CITY OF ALBUQUERQUE

October 25, 2018

RE: Broadstone Northpoint Townhomes
9100 San Mateo Blvd NE
Engineer's Stamp Date: 09/16/16
Engineer's Certification Dated 10/18/18
Hydrology File: B18D001C
CPN #786480

Based on the information provided in your submittal received 10/22/18 and site visit on 10/24/18, the Engineer's Certification is **not** approved for ROFG/SIA for Hydrology. The following comments need to be addressed for approval of the above referenced project (please note that these were on the punch list after the walkthrough a few months back):

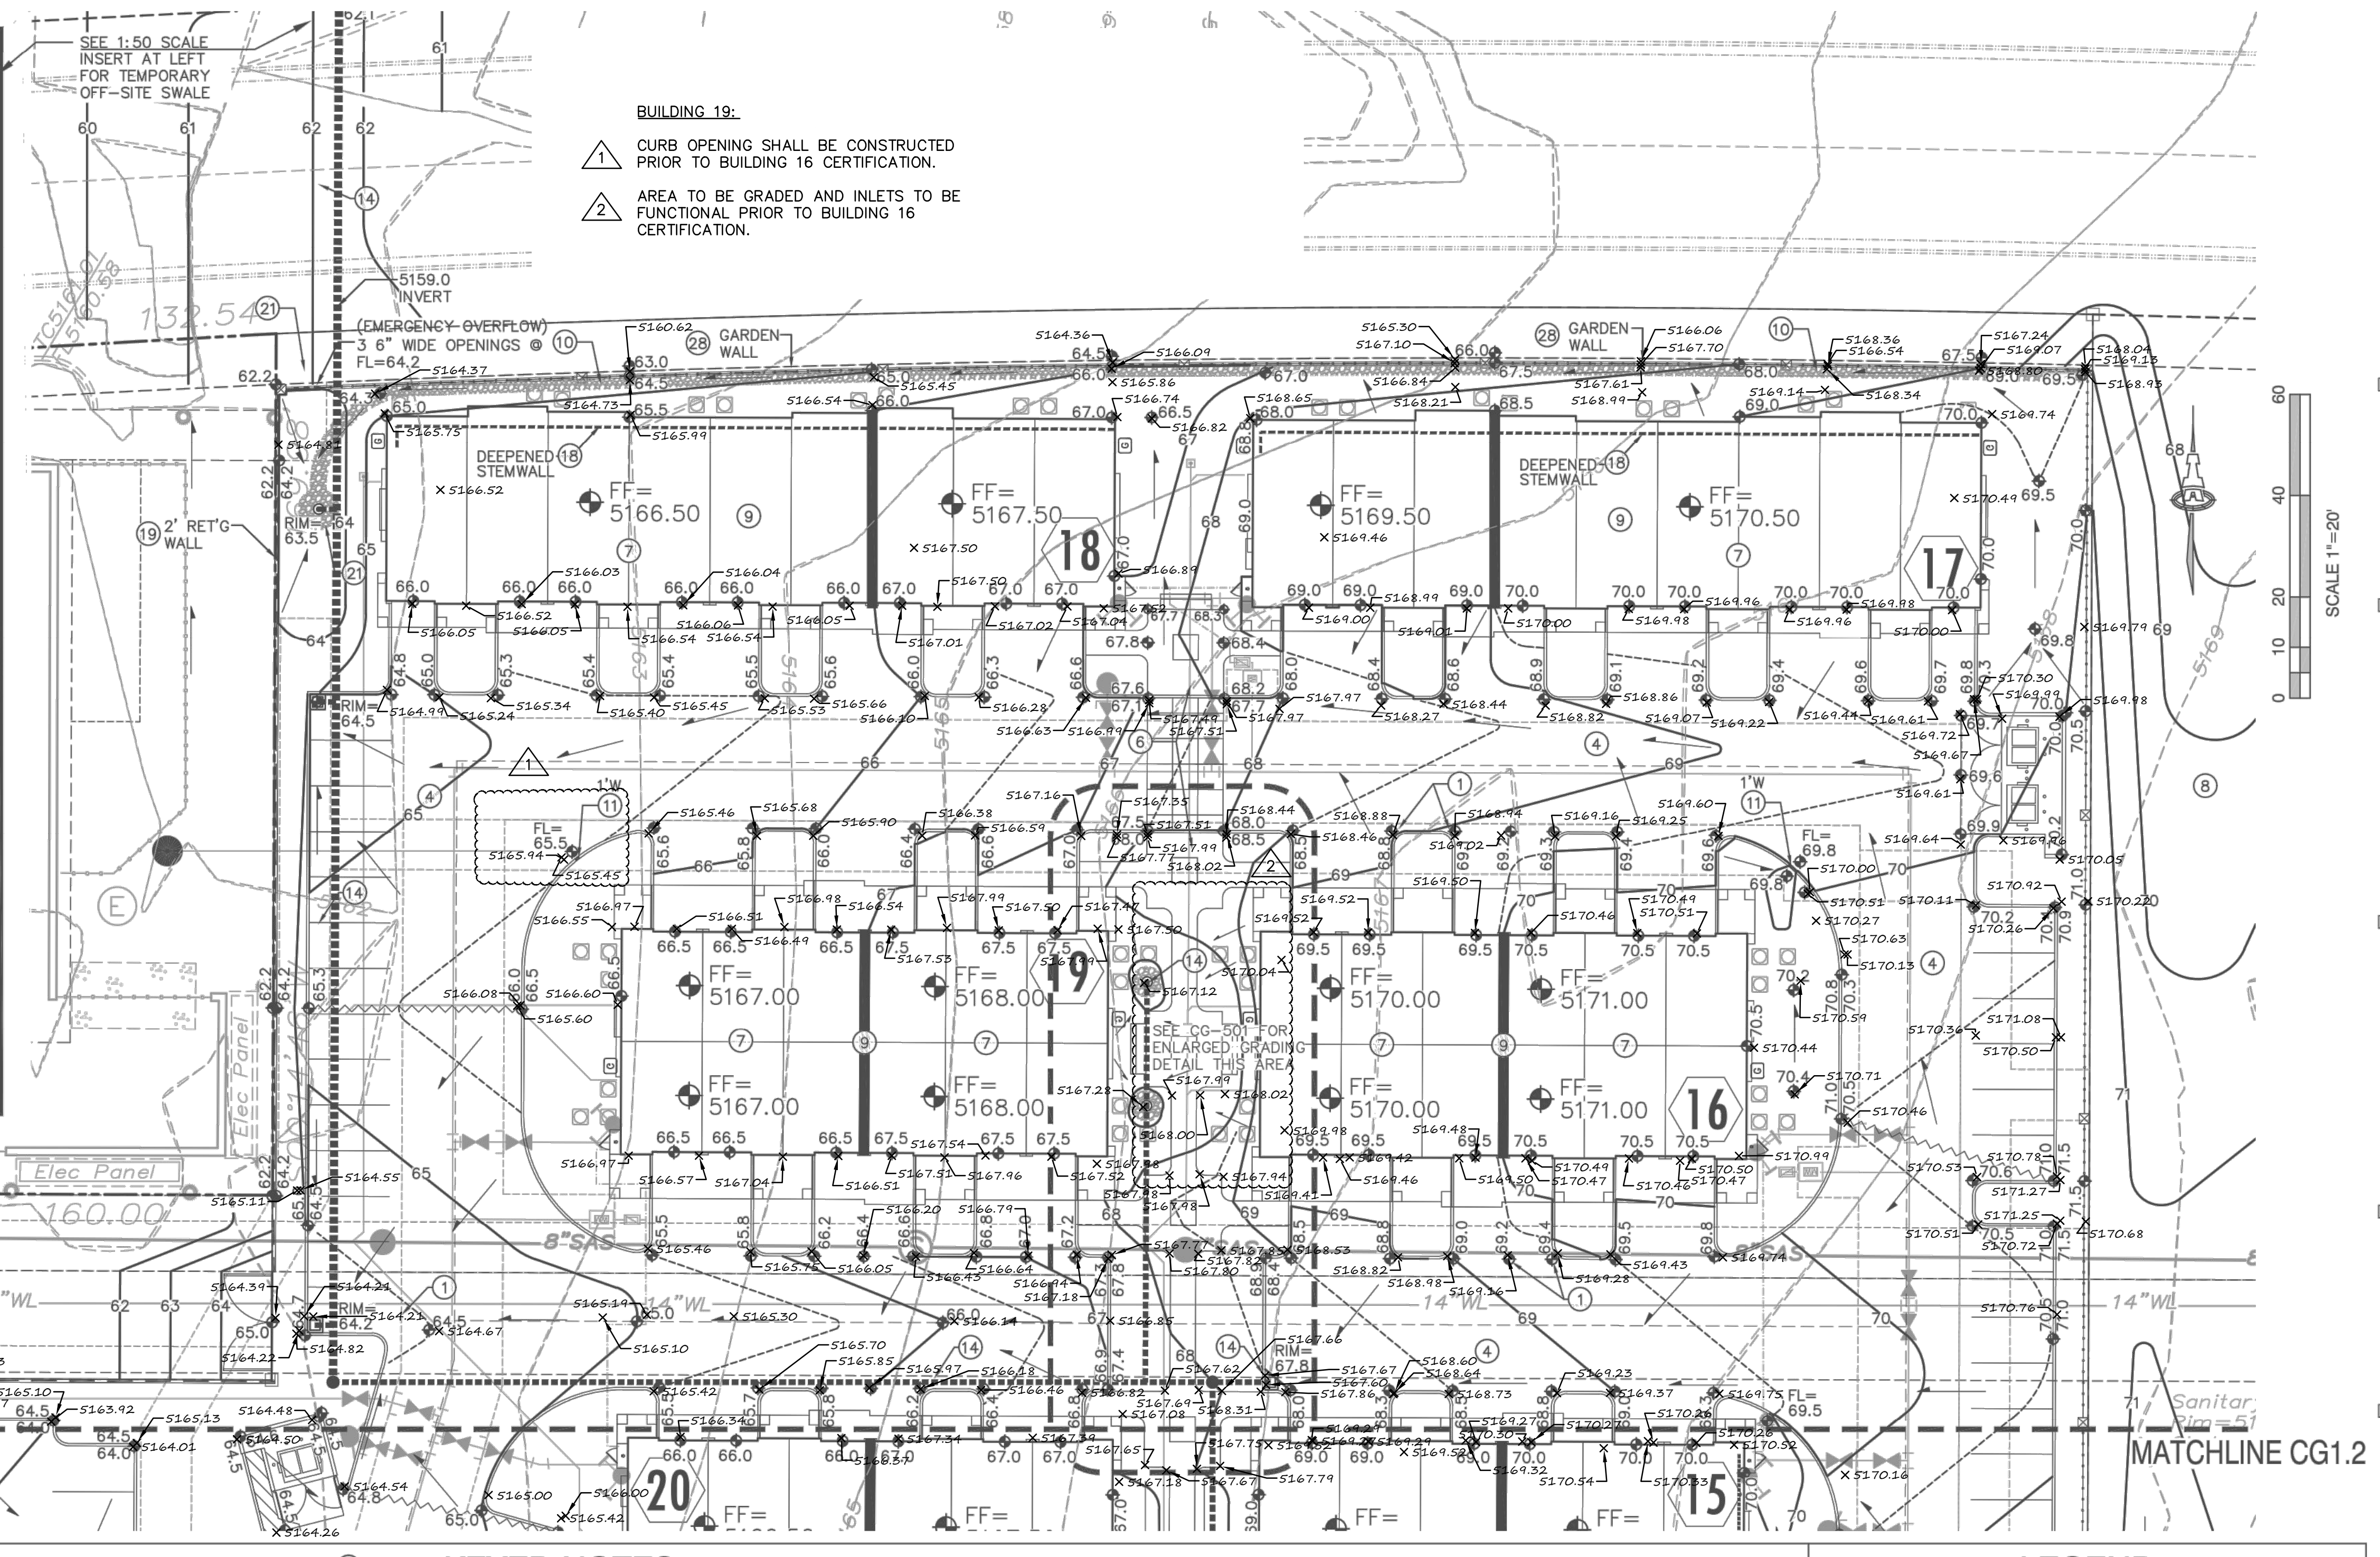
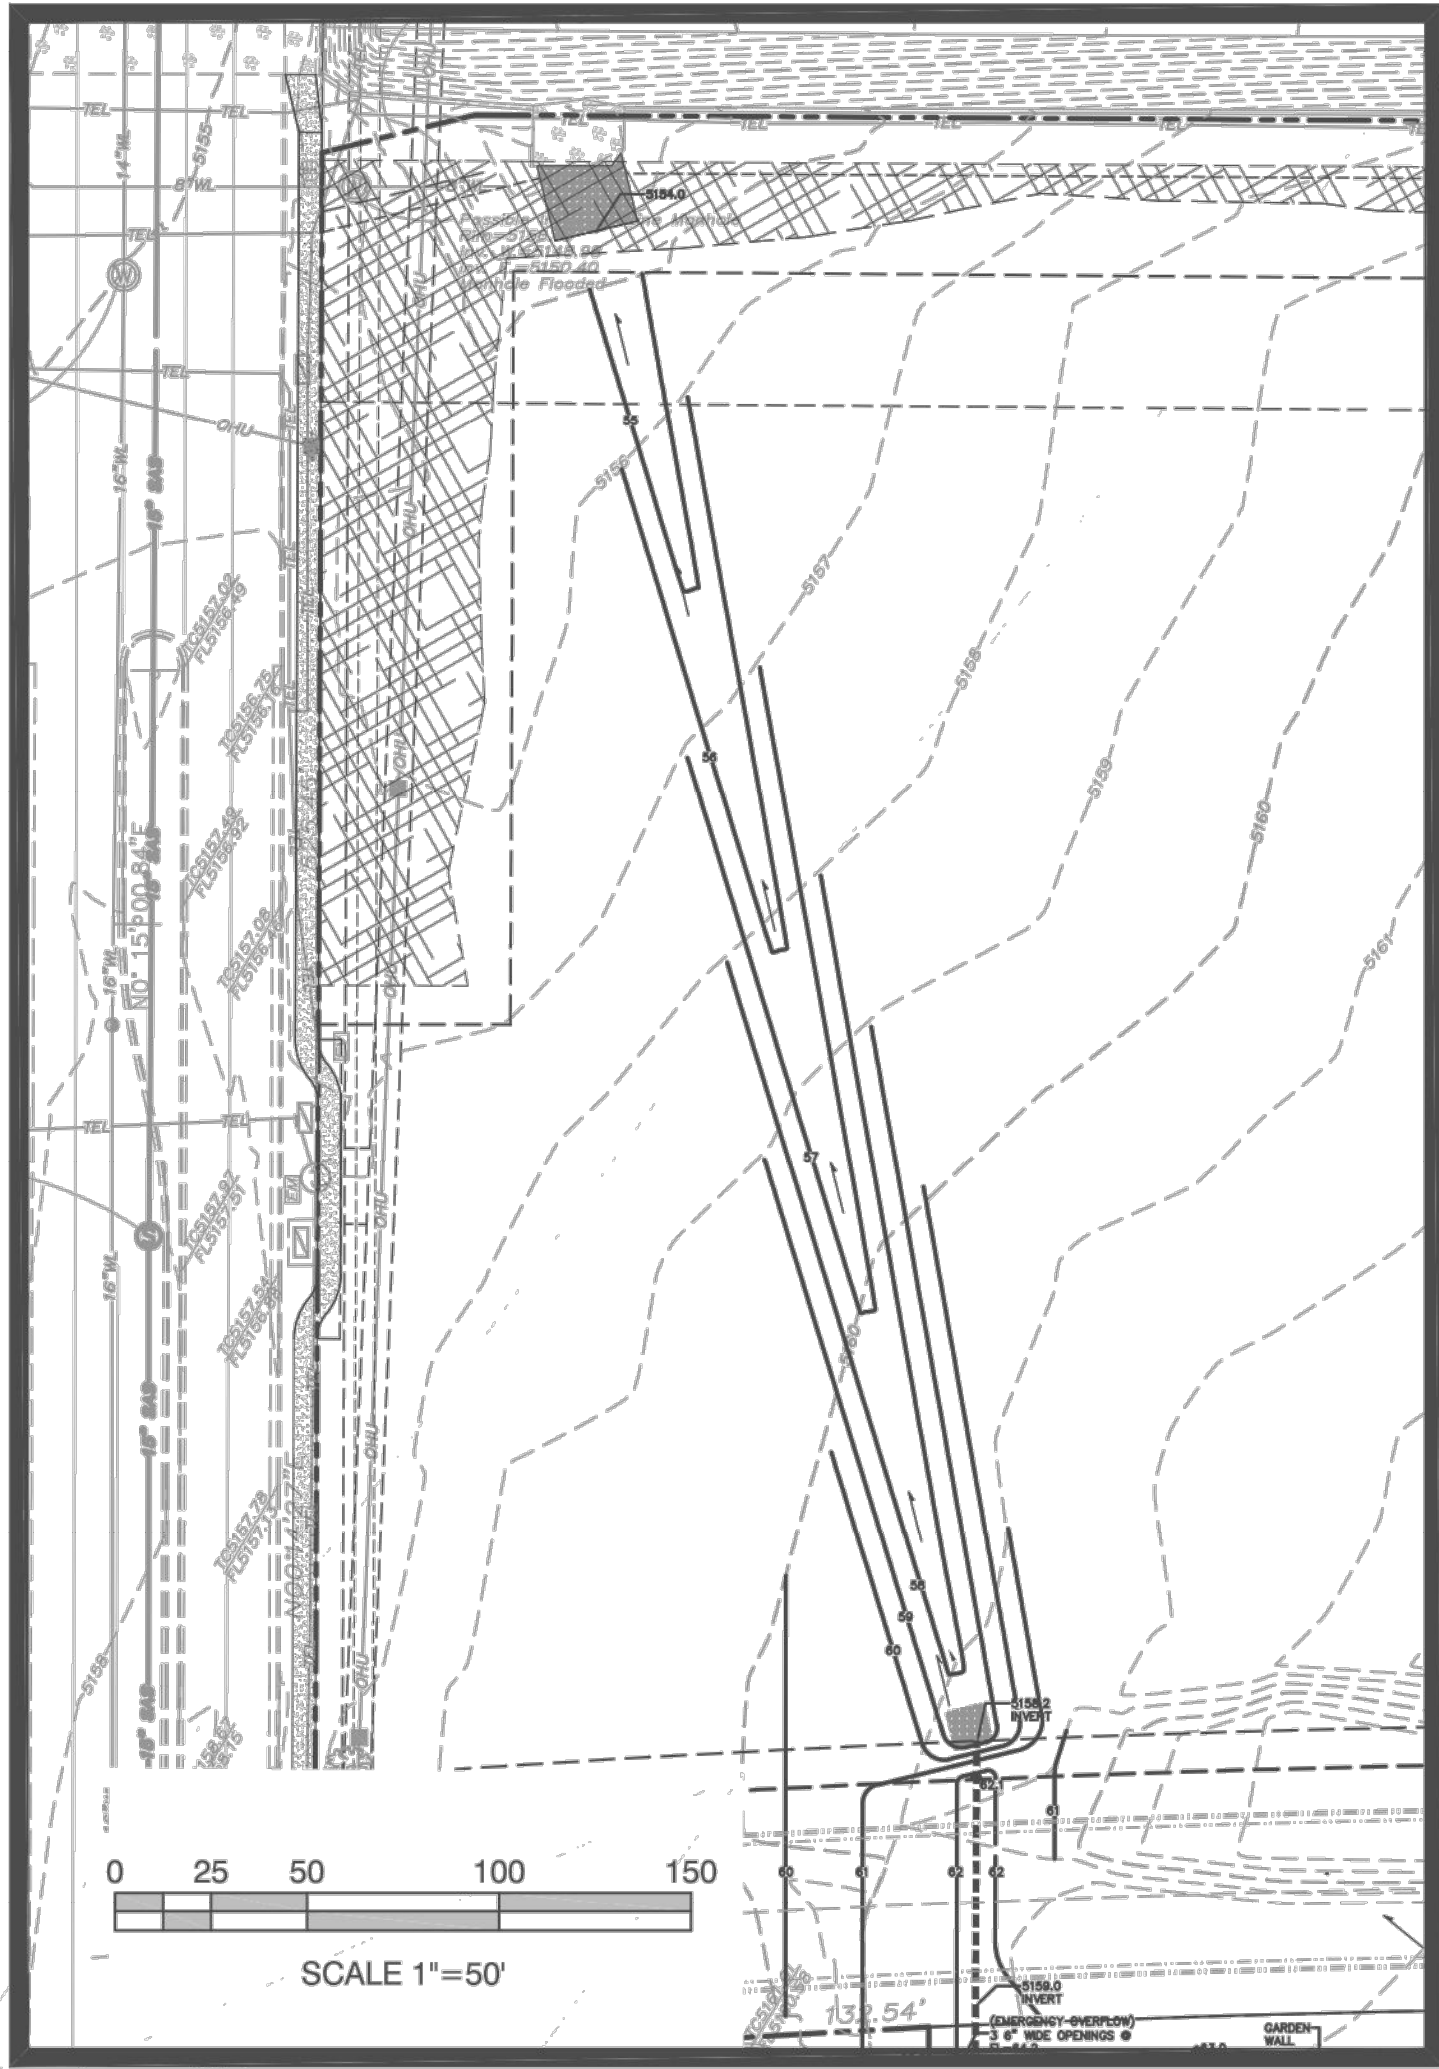
1. There are some several erosion problems along the channel which are undermining the concrete slabs. (See the photos below.)

2. The other issue as to due to with the low flows in the bottom are entering between the slabs and flowing underneath them and out falling right at the pipes. This is also undermining the concrete slabs. (See the photos below.)
